intel® Technical Advisory

TA-550-1

April 25, 2002

Erroneous temperature readings from onboard thermal sensors on some SCB2 (SCSI) Server Boards

Black dot showing a screened -607 board

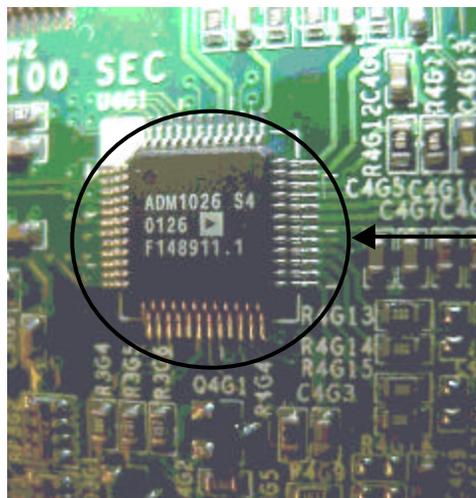
- All -607 SCB2 (SCSI) server boards shipped from Intel after April 15, 2002 will be screened to have the rev. 4 ADM1026 sensor chip. All screened product will show a black dot on the serial number label on the server board as well as on the outside of the packaging next to the serial number on the printed label.
